**AMENDMENT #1 TO:**

<b>Title-Sujet</b> CAVE & BASIN BELVEDERE DECK & STRUCTURE REHABILITATION, Banff NP, Banff, AB		
<b>Solicitation No. - No. de l'invitation</b> 5P421-18-1074/A		<b>Date:</b> October 16, 2018
<b>GETS Reference No. - No de reference de SEAG</b> PW-18-00845874		<b>Client Ref. No. - No. de réf du client.</b>
<b>Solicitation Closes:</b>		
<b>at - à</b> 02:00 PM	<b>on - le</b> October 23, 2018	<b>Time Zone - Fuseau horaire</b> Mountain Daylight Time (MDT) - Heure avancée des Rocheuses (HAR)
<b>F.O.B. - F.A.B.</b> <b>Plant-Usine:</b> <input type="checkbox"/> <b>Destination:</b> <input checked="" type="checkbox"/> <b>Other-Autre:</b> <input type="checkbox"/>		
<b>Address Inquiries to: - Adresser toute demande de renseignements à :</b> Annie Roy                      annie.roy@pc.gc.ca		
<b>Telephone No. - No de téléphone</b> 403-762-1459		<b>Fax No. - No de FAX:</b> 403-762-5057
<b>Destination of Goods, Services, and Construction:</b> <b>Destinations des biens, services et construction:</b>  See Herein - Voir ci-joint

## **AMENDMENT # 1**

### **#1. Addenda 01 is added to the Invitation to Tender package for this project:**

Sketch 01

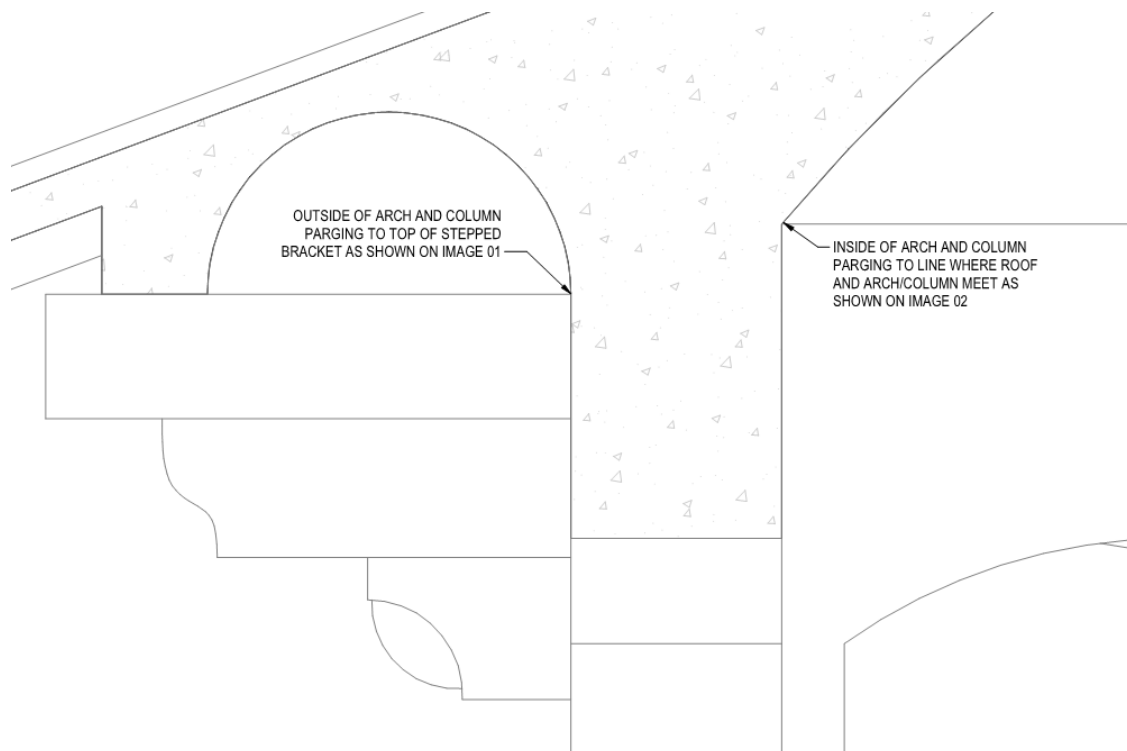
#### 1. Extent of Parging at Columns and Arches

As shown on Sketch 01, Image 01 and Image 02, on 'outside' of columns and arches parging to go to top of stepped bracket, with a continuous horizontal line to all 'outside' faces. On the inside of columns and arch parging to line where roof and arch/column meet.
